**ITEM III-A: DESIGN REVIEW PERMIT – NERSP PARCEL 14 - OILSTOP – 330 N. SUNRISE AV. –
FILE # 2013PL-046 (PROJECT # DRP-000498)**

REQUEST

The applicant requests approval of a Design Review Permit to construct a 2,912 square foot drive through oil change (automotive repair) facility with associated site improvements.

Figure 2: Site Plan

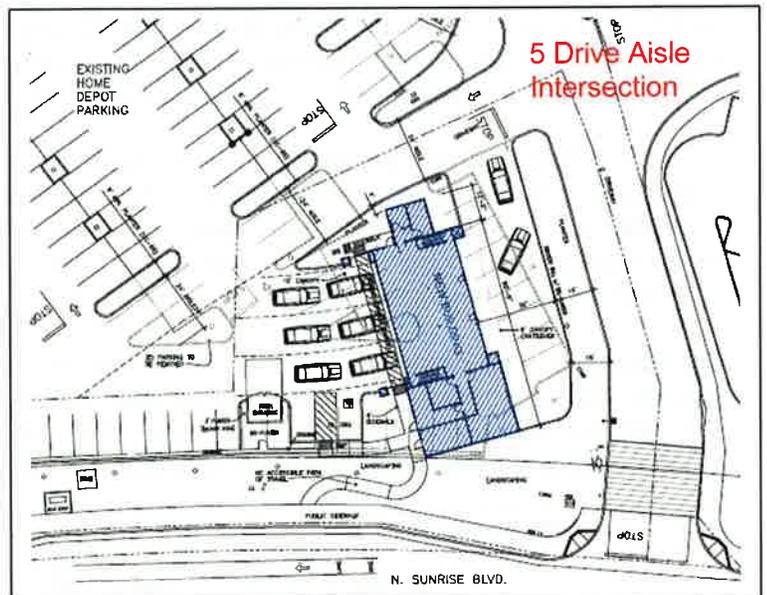
The internal circulation pattern will include the reconfiguration of one main drive aisle located along the eastern edge of the Home Depot site. This drive aisle currently creates awkward turning movements at the intersection to the Home Depot parking field (see Figure 2 above). At this intersection there are five drive aisles that connect in this location. This design creates confusion for motorists and also creates conflicts between customers and truck deliveries. This entrance from North Sunrise Av. is an area where delivery trucks proceed to the rear of the Home Depot store. Staff and the applicant have worked to develop a circulation pattern that will align the drive aisles between the northern and southern portions of the center, while also eliminating one of the drive aisles that currently terminates in this area. Staff

believes this design will better define the turning movements for motorists and create a safer circulation pattern.

SHEET TITLE
 NORTH & WEST
 EXTERIOR ELEVATIONS

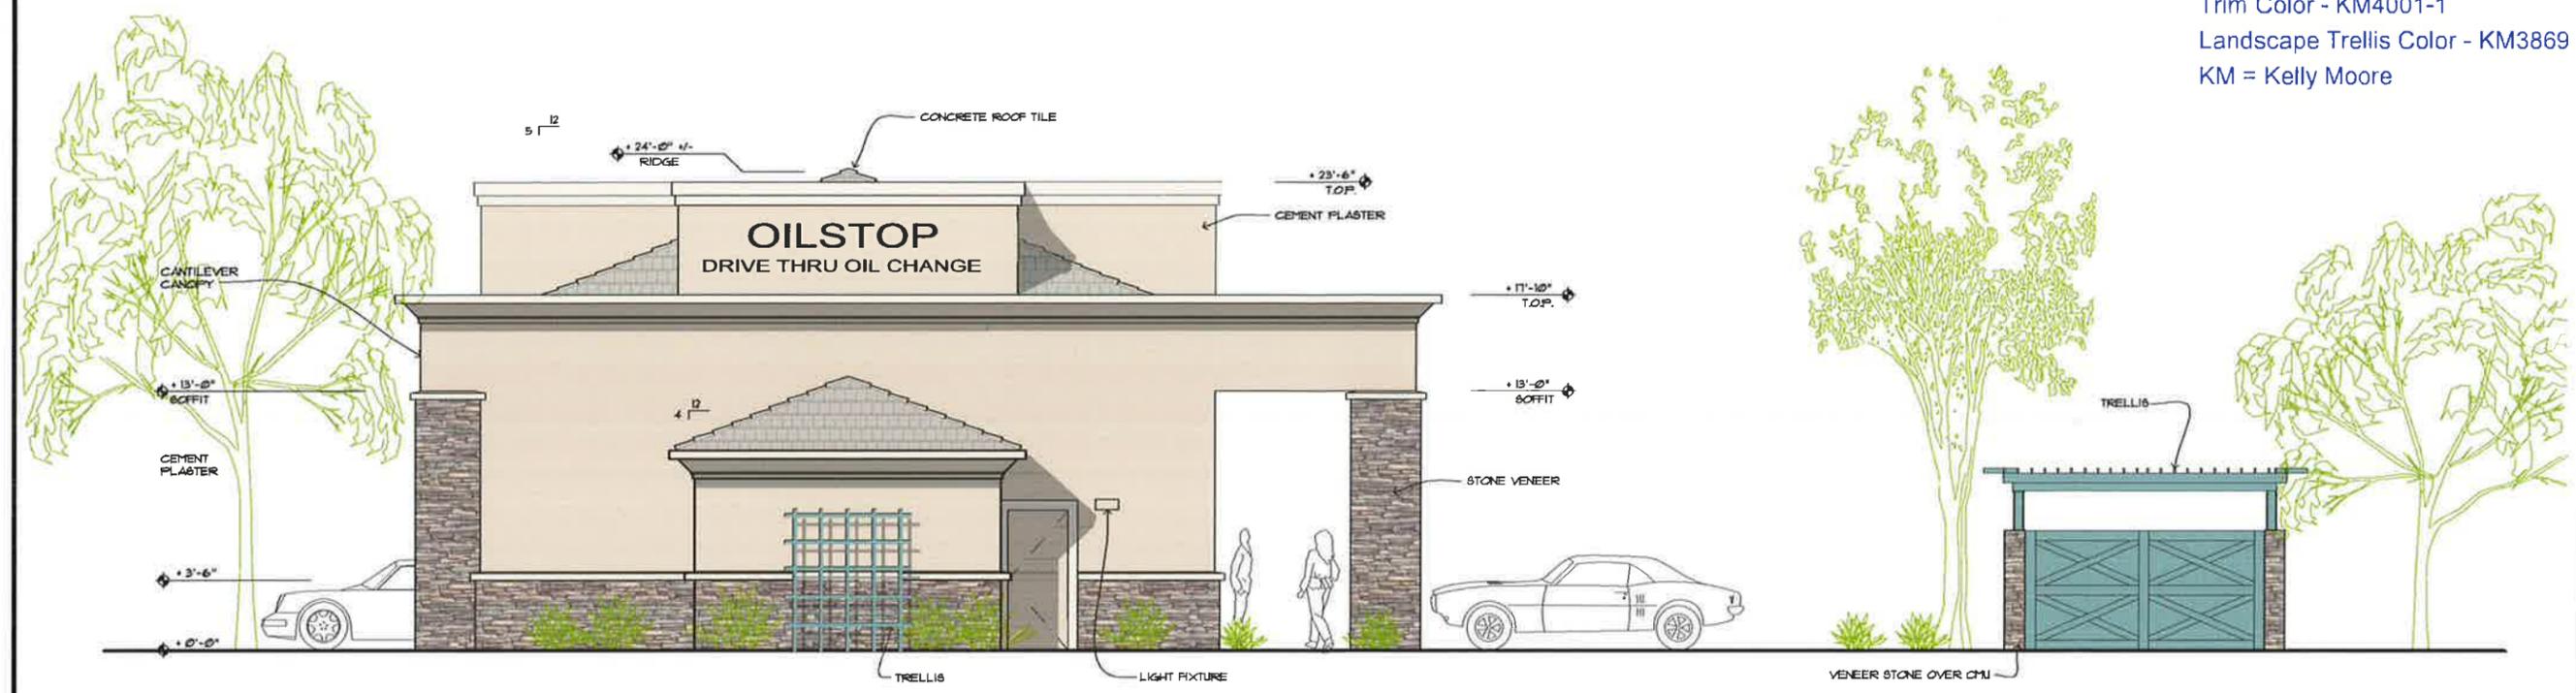
Staff is recommending the applicant lighten the trim color on the building to provide a greater contrast between the main tan field color and the building’s trim color. Other recently approved building renovations within the center such as Sierra Pacific Bank incorporate similar color schemes with a dark field color and lighter trim color. This will help to accentuate the roofline of the building. Condition #3 has been added to the project to require the applicant to provide a lighter trim color to the satisfaction of the Planning Division.

3. The applicant shall modify the building trim color to the satisfaction of the Planning Division. (Planning)
4. The applicant shall pay City's actual costs for providing plan check, mapping, GIS, and inspection services. This may be a combination of staff costs and direct billing for contract professional services. (Engineering, Environmental Utilities, Finance)

SHEET TITLE
 EAST & SOUTH
 EXTERIOR ELEVATIONS

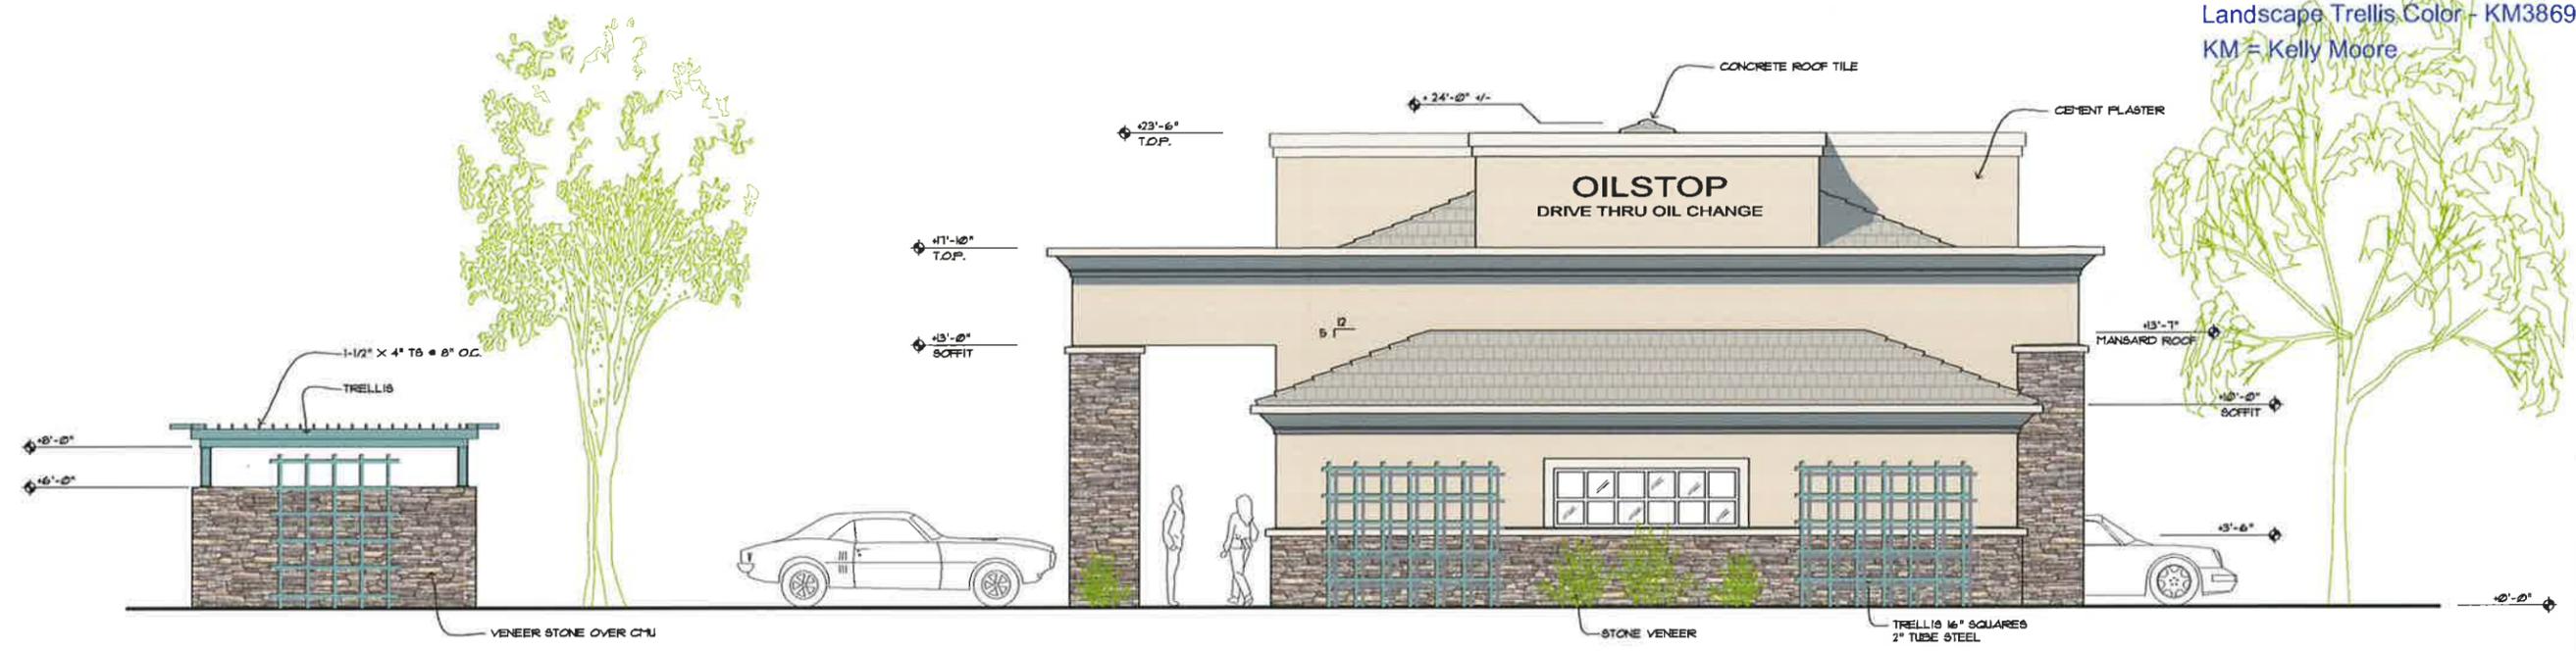
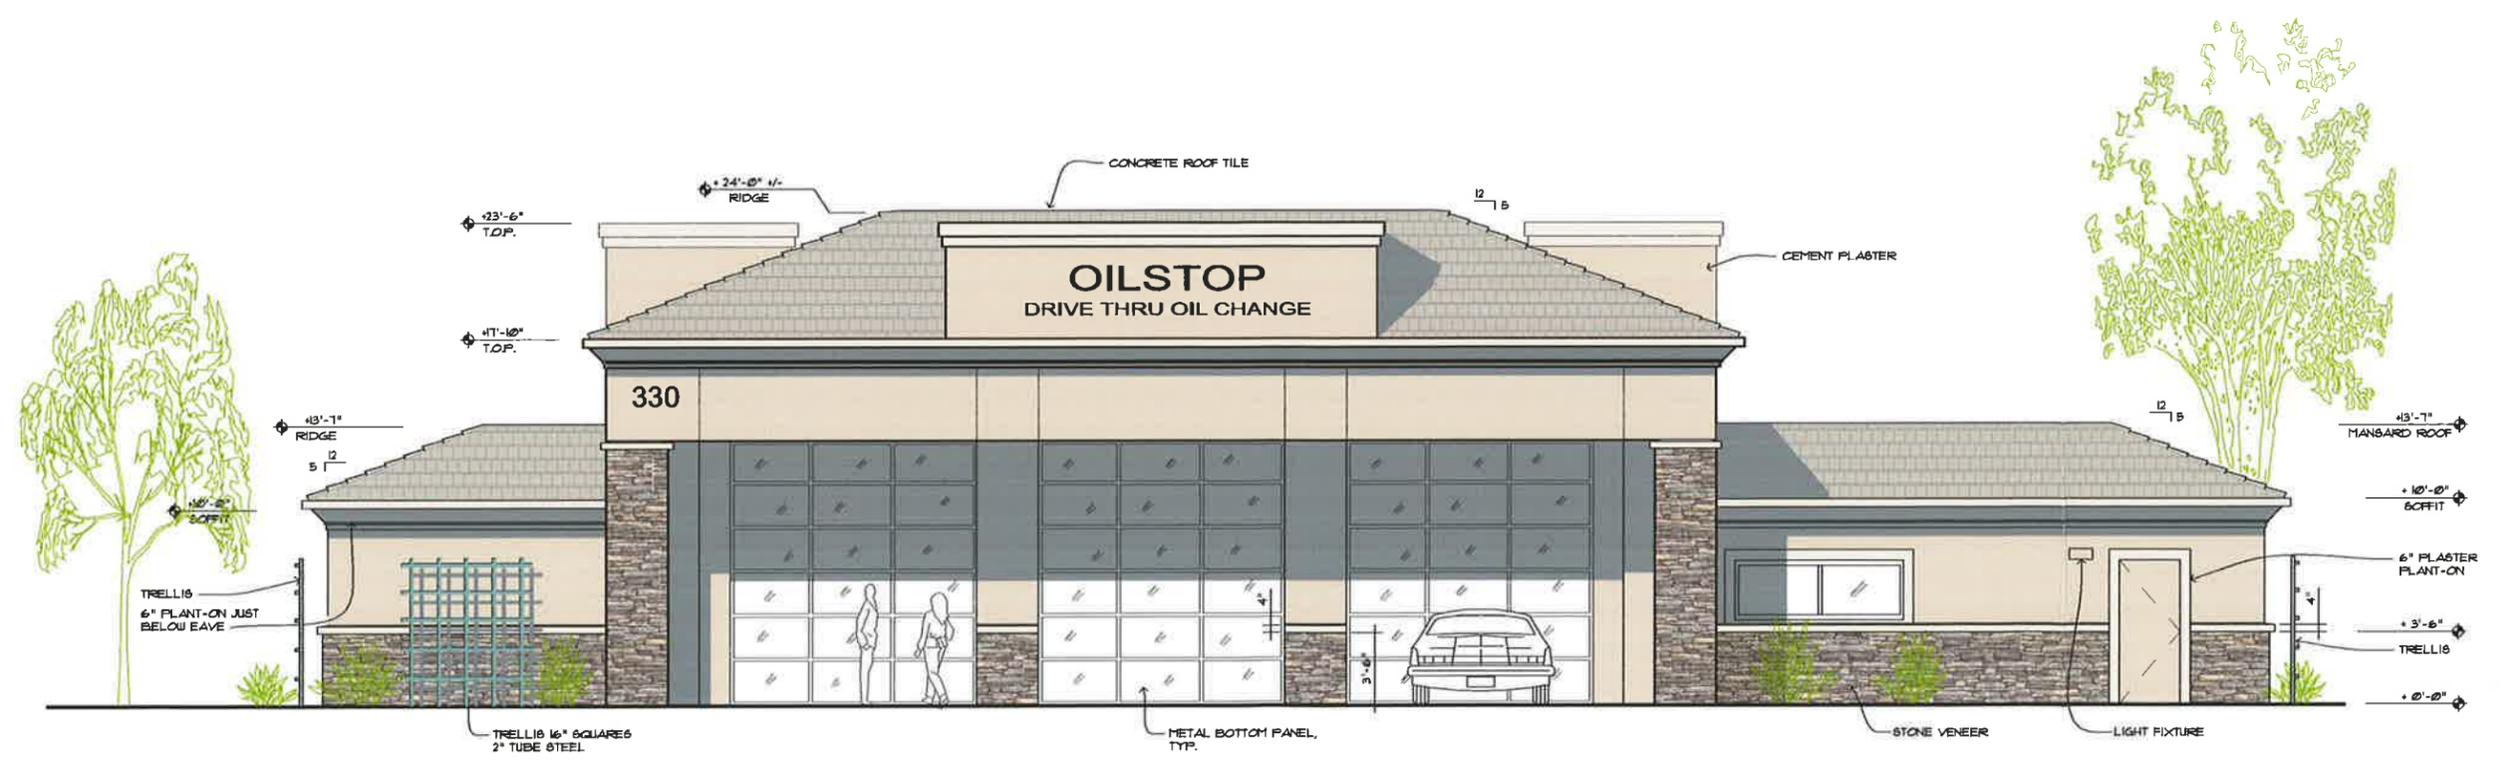
As proposed, the project will provide a strong streetscape presence emphasized through depth, shade and shadow contrast, and pedestrian scale architectural features (i.e. columns, trellis, and decorative wall planes). In addition, the east elevation fronting North Sunrise Av. will have windows, stacked stone, and trellis features as well.
